CITY OF PLANO COUNCIL AGENDA ITEM

Subject: Appeal of the Heritage Commission's partial denial of a Certificate of Appropriateness to enlarge the existing second floor addition at the front (north) façade and install new windows on the east and the west facades at 1022 E. 15th Street.

Re: Request for Appeal to Plano City Council (the “**City Council**”) of the City of Plano Heritage Commission (the “**Heritage Commission**”) Denial of Request for Certificate of Appropriateness for 1022 E. 15th Street at Heritage Commission Meeting of November 18, 2014

Certificate of Appropriateness: 1022 E. 15th Street

LEFT ELEVATION
SCALE: 1/8" = 1'-0"

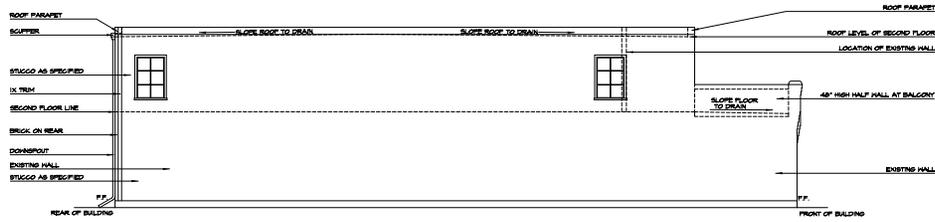
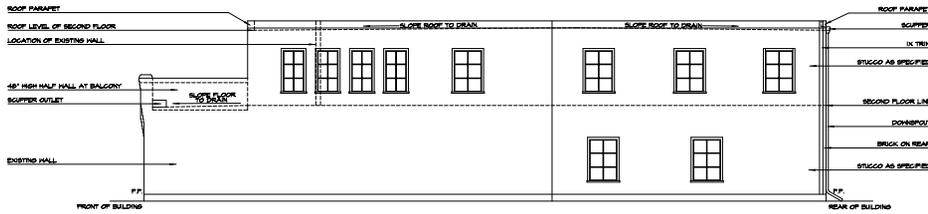
- Proposed second floor expansion will be visible from E. 15th Street.
- Concern that approving the requested expansion project will set a bad precedent for other historic structures located within the Downtown Heritage Resource District.
- Requested windows on the east and the west façade may not meet the city's adopted 2012 International Building Code.
- No evidence of historic windows on the existing east and the west façade.

The Commission stated that the proposed CA application to enlarge the existing second story addition at front (north) façade and install new windows at the east and the west elevation does not comply with Sections 3.6 and 10.3 of the Downtown Heritage District Design Guidelines. A simple majority vote of 5 of the 8 City Council members is required for approval of the appeal request.

Owner believes the Historic Commission also erred in denying the proposed new windows based on Section 3.6 of the Guidelines. Section 3.6 of the Guidelines applies to new window openings in facades, which traditionally means the front of a building. The new windows would not be in the front but rather on the east and west sides of the building, out of view from the front.

- Section 1.3 for General;
 - Section 2.1 for Facades/Storefronts; and
 - Section 3.2 and 3.3 for Windows and Doors.
2. The proposed windows at east and west facade do not meet Section 3.6 of the Downtown Heritage Resource District Guidelines for Windows and Doors. Although there is no historic evidence of windows on the east and west facades, staff believes the requested new windows shall be minimally visible from 15th Street and most importantly bring in more natural light to create a healthy environment for the proposed new office use/spaces. Additionally, the proposed window size, style and locations are compatible to the architectural style of the building and the district. Therefore, staff believes the installation of new windows in this instance would help improve the overall building fenestration without having an adverse effect on the historic character of the building or district.

The CA request for the (#1) New Windows and (#3) Second Floor Expansion were not approved due to non-compliance with Sections 3.6 and 10.3 of the Downtown Heritage District Design Guidelines.
